Access Compliance Report

Public Rights-of-Way

(Curb Ramps)

Intersection ID: 3559	Main Street: PERIMETER_PY	Cross Street: W_W_T_HARRIS_BV	Location: SW
ADA ID: 4B265E850994	Ramp Type: Perp	Initial Pass/Fail: Fail	Overall Compliance: No
			Severity Score: 10

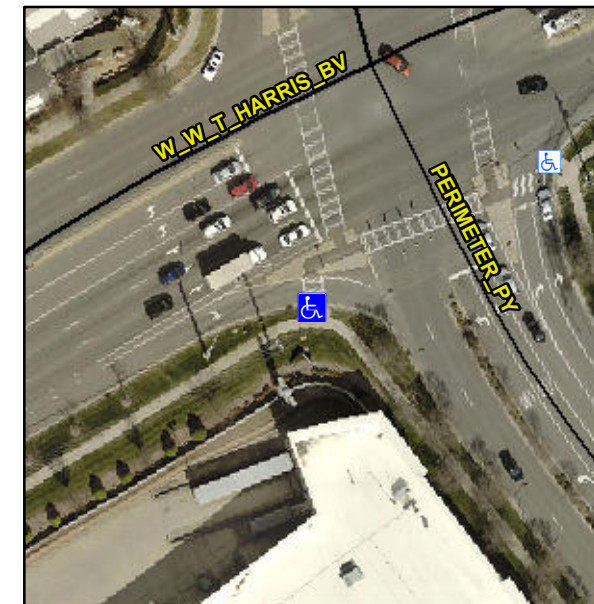
Not Found, R304.5.1, R304.5.3

Compliance	Description	Data	Compliance	Description	Data
N/A	Ramp Length (in)	60.0	Yes	Ramp Slope (%)	8.2
No	Ramp Width (in)	46.0	No	Ramp XSlope (%)	3.6
N/A	Flare Type LT	N/A	N/A	Flare Type RT	N/A
N/A	Flare Slope LT (%)	N/A	N/A	Flare Slope RT (%)	N/A
N/A	Flare Traversable LT?	N/A	N/A	Flare Traversable RT?	N/A
N/A	Landing Length (in)	N/A	N/A	DWS Provided?	N/A
N/A	Landing Width (in)	N/A	N/A	DWS Contrast?	N/A
N/A	Landing Slope (%)	N/A	N/A	DWS Length (in)	N/A
N/A	Landing X Slope (%)	N/A	N/A	DWS Full Width?	N/A
N/A	Landing Curb? (Y/N)	N/A	N/A	DWS Offset (in)	N/A
N/A	Shared Landing?	N/A			
N/A	Gutter Ponding?	N/A	N/A	Gutter Slope (%)	N/A
N/A	Gutter Lip Ht (in)	N/A	N/A	Gutter X Slope (%)	N/A
N/A	Painted X Walk1?	Yes	N/A	Painted X Walk2?	N/A
	X Walk 1 Direction	To NE		X Walk 2 Direction	N/A
N/A	X Walk 1 Width (in)	112.0	N/A	X Walk 2 Width (in)	N/A
	X Walk 1 Slope (%)	4.6		X Walk 2 Slope (%)	N/A
	X Walk 1 X Slope (%)	3.1		X Walk 2 X Slope (%)	N/A

Remove & Replace Entire Ramp.
